ADDENDUM

Project: Craft State Office Building 1 HVAC
– 200 South Silber Avenue, North
Platte, NE, 69101

Project No.: 23059

Addendum No.: 1

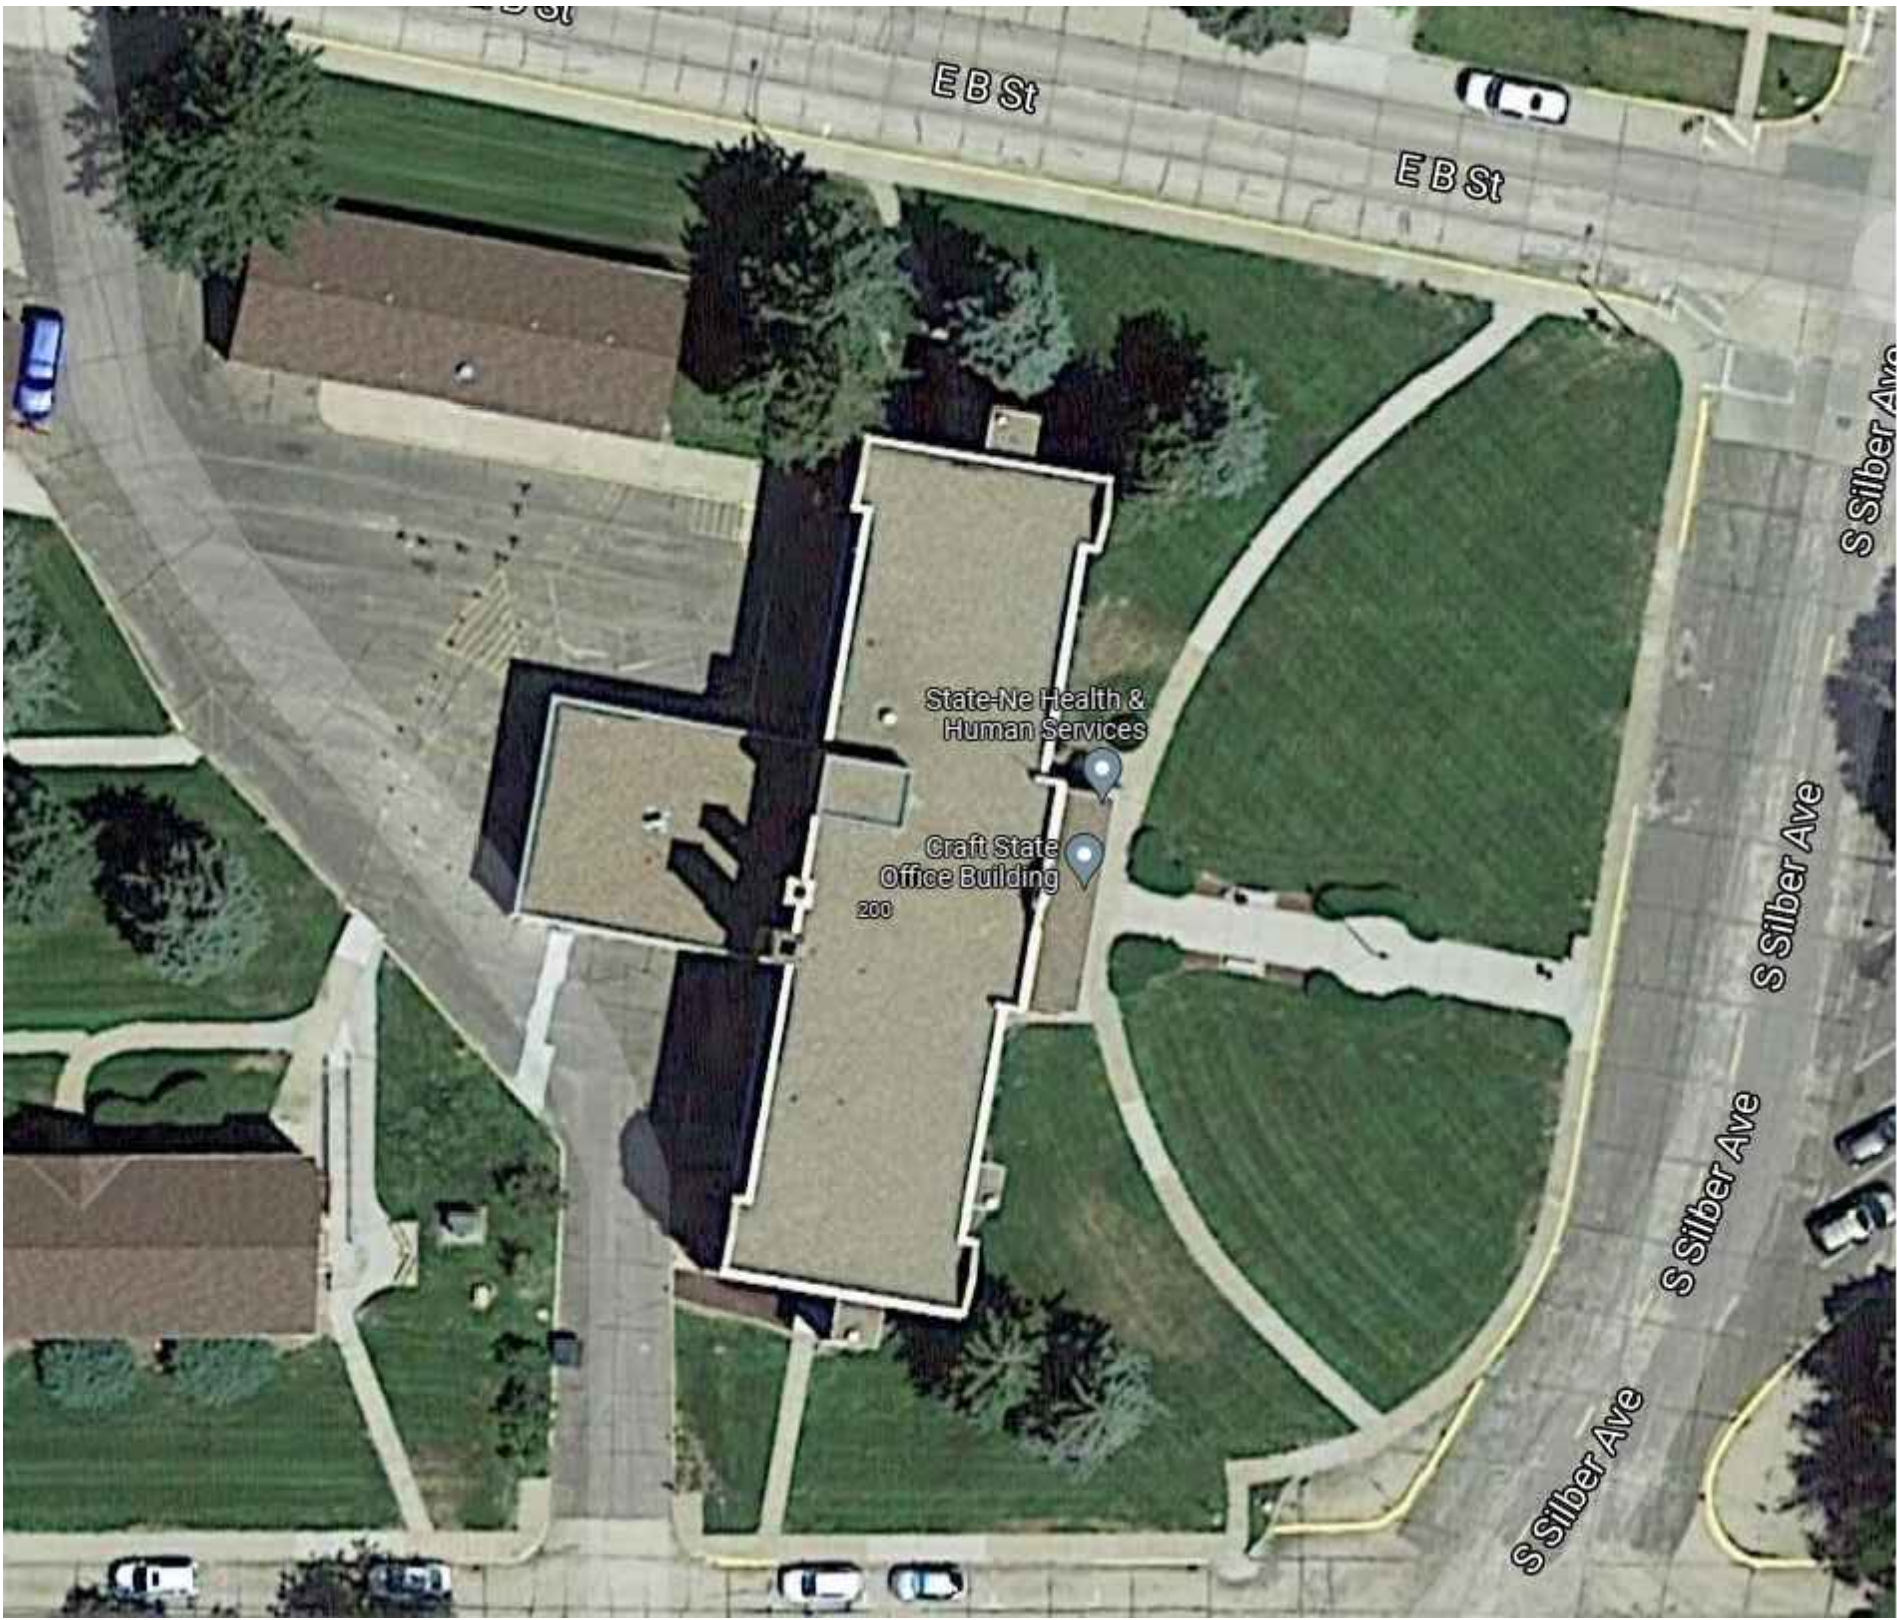
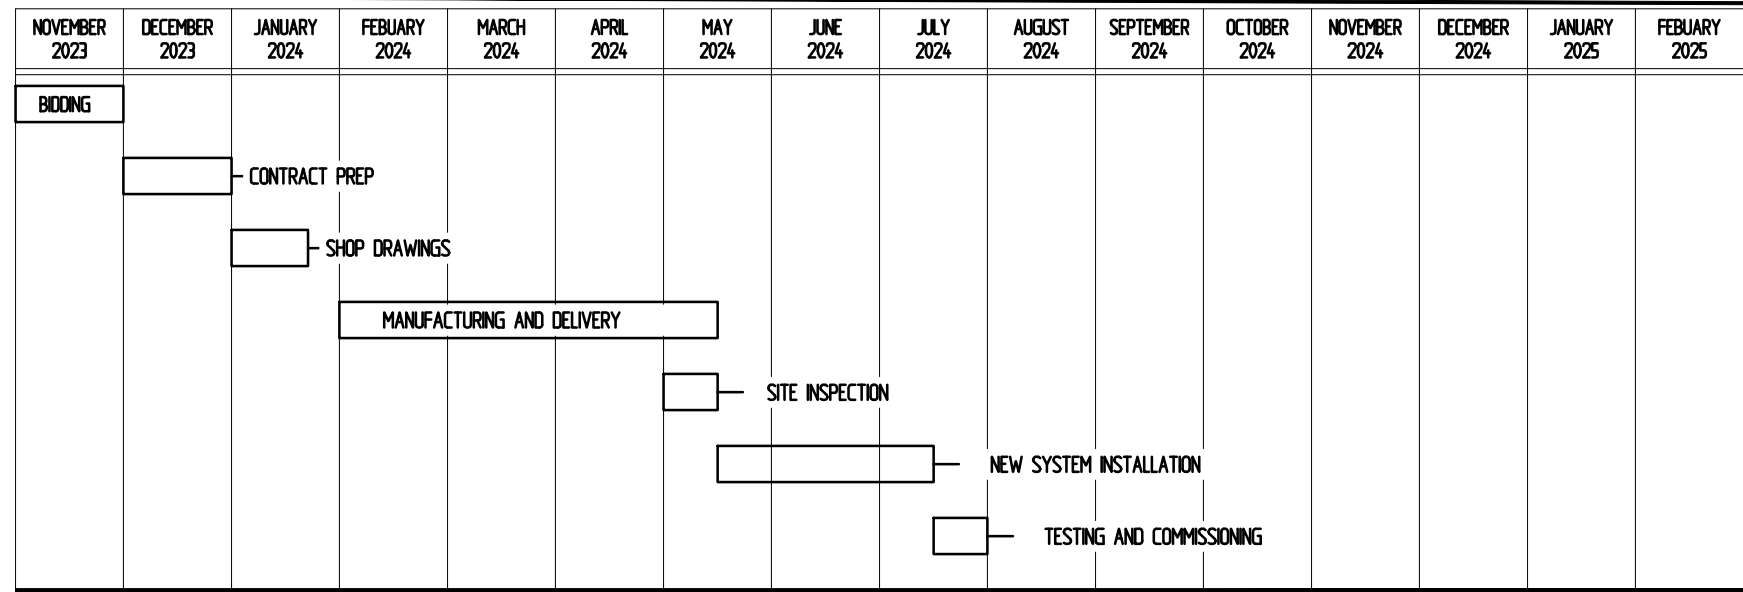
1. **T0.0 – Title Sheet**
 - a. Several notes we added to the "Overall Project Phasing Schedule."
 - b. Outlined alternative and base bid proposed by structural.
 - c. Added sheet to Structural Sheet list.
2. **M1.1 - GROUND & FIRST FLOOR PLAN - MECHANICAL**
 - a. Keynote 3 has been revised to specify relocating the (E)MSCU.
 - b. Keynote 4 has been revised to specify the removal of the existing refrigerant and humidity drain piping.
3. **M1.2 – Second and Third Floor Plan – Mechanical**
 - a. Keynote 3 has been revised to specify the addition of the Roof Hydrant.
 - b. keynote 4 has been revised to specify new location of (E)MSCU.
 - c. Keynote 5 has been revised to specify refrigerant piping from new location of (E)MS to new location of (E)MSCU.
4. **M2.1 – Details & Schedules - Mechanical**
 - a. Plumbing fixture schedule and RH-1 have been added to this sheet.

- BASE BID
 - (2) 4"Ø CORE DRILLS OF THE EXISTING SLAB
 - DEMOLITION OF BASEMENT WALLS AND SLAB, UNDERPINNING, SHORING, NEW SLAB, AND WALLS AS SHOWN ON SHEET S11
- ALTERNATE: A-1
 - REDUCT: DEMOLITION, UNDERPINNING, SHORING, NEW WALLS AND NEW SLAB AT BASEMENT LEVEL
 - ADD GRINDING OF EXISTING PIT SLAB DOWN 1 1/2' CUT IN NEW SUMP PIT, INFILL EXISTING OPENING AT BASEMENT LEVEL, DEMOLITION FOR NEW ELEVATOR OPENING AT BASEMENT LEVEL, INFILL OF ROUGH OPENING AFTER ELEVATOR IS INSTALLED, PATCH AND REPAIR OF (Ø) CORE DRILL

ALTERNATE #1 FLOOR PLAN

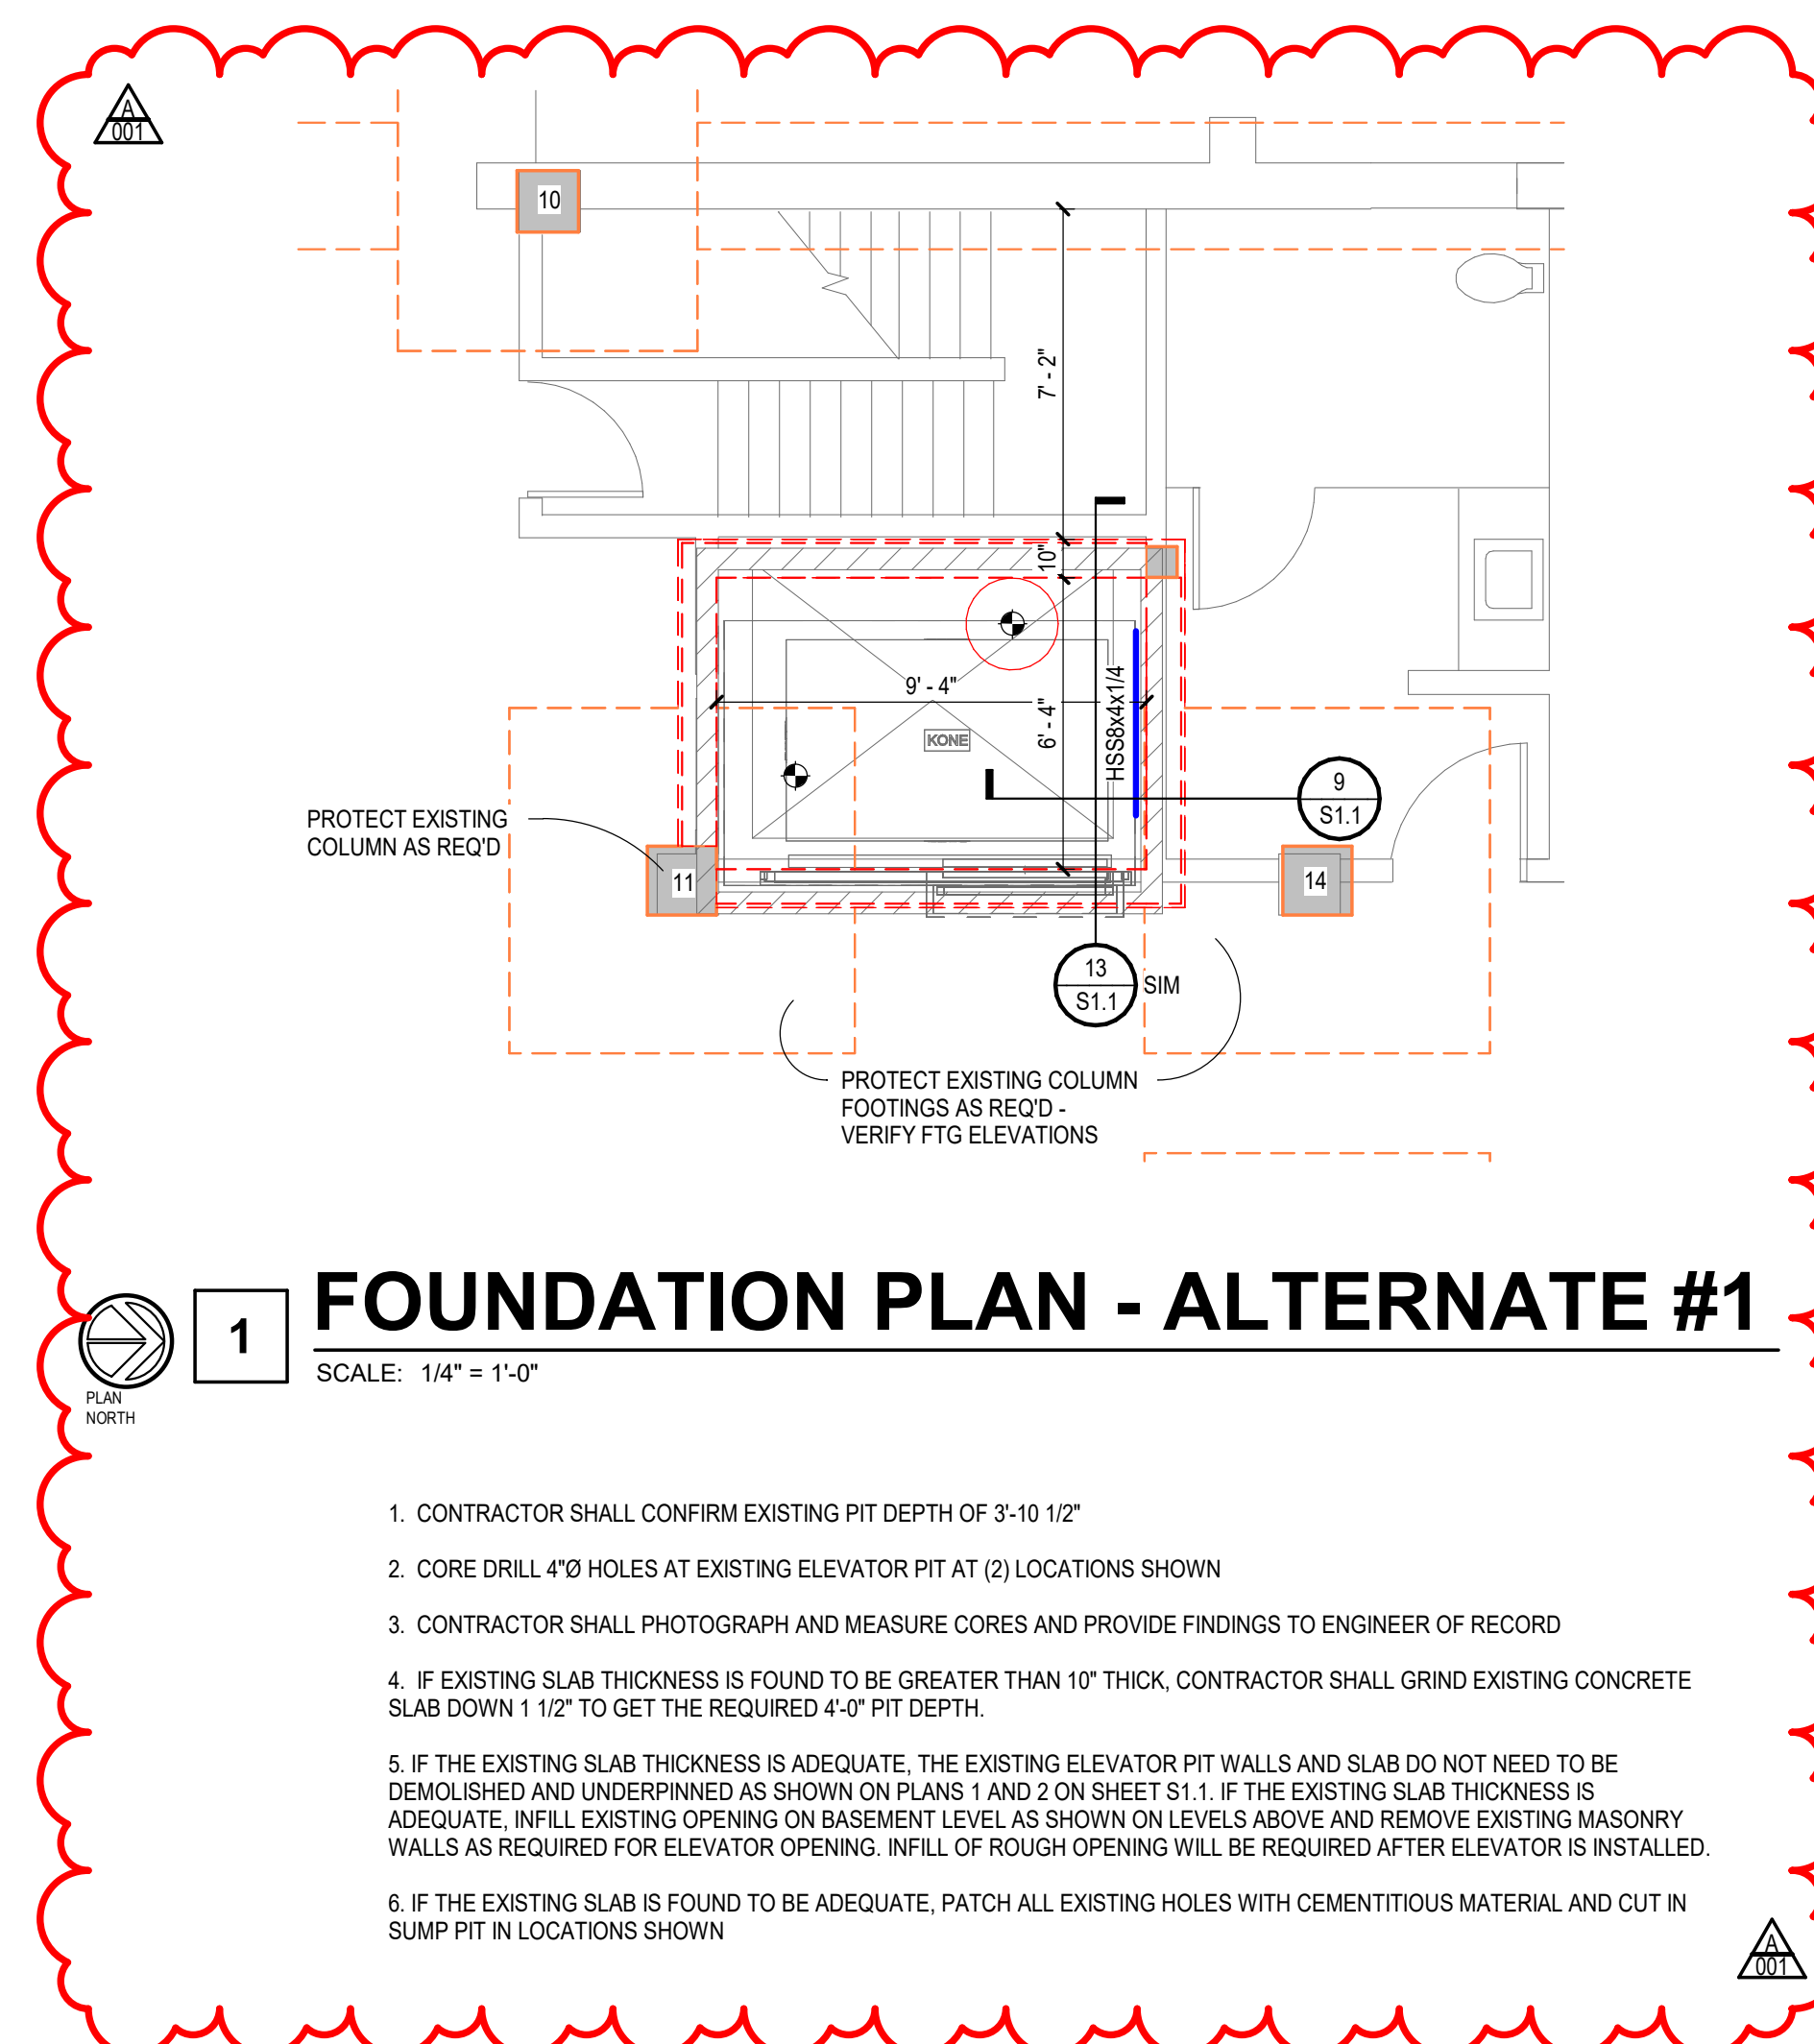
3. **S1.1 – Floor Plans & Details**
 - a. This sheet was revised.
4. **S1.2 – Alternate #1 Floor Plan**
 - a. This sheet was added.
